## MODIFYING A WORD CLOCK INPUT FOR LOW LEVEL SOURCE

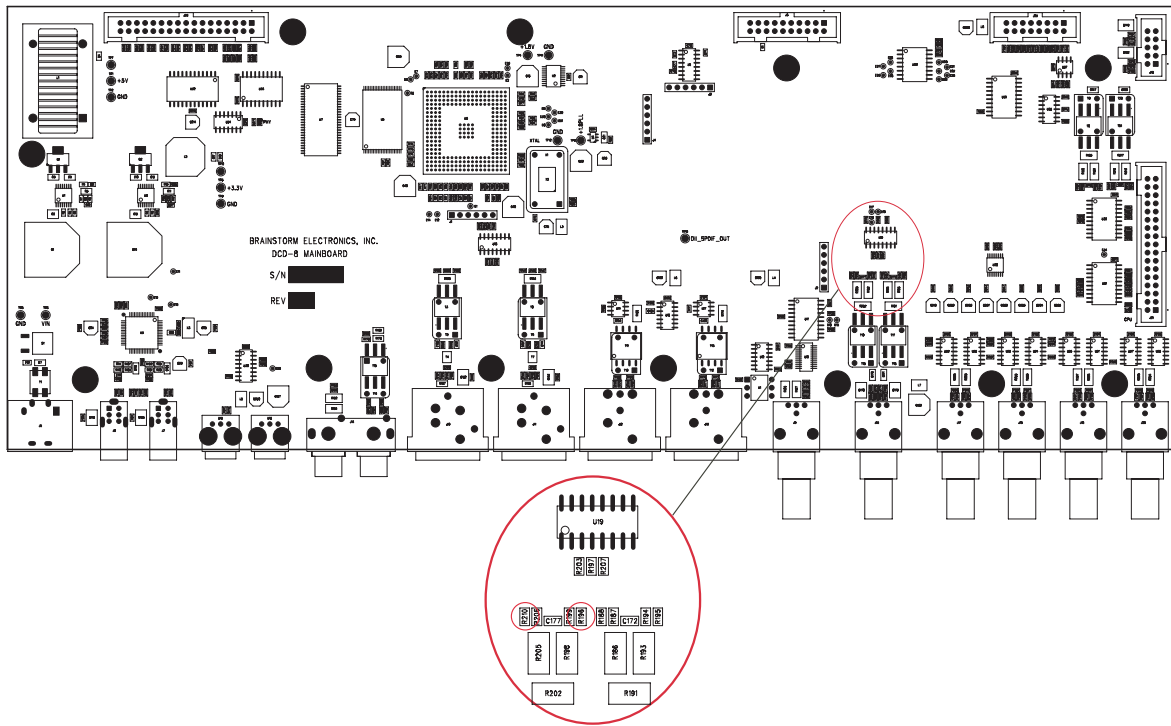
For those situations, 2 resistors can be removed, changing the minimum required input level to 0.20Vp-p.

- locate R196 and R210. Normal value for both resistors is 4.7K $\Omega$ .
- Remove those resistors.

Inputs 1 & 3 can be modified the same way. The resistors to remove for those inputs are:

- INPUT 1: R188 & R195
- INPUT 3: R214 & R221
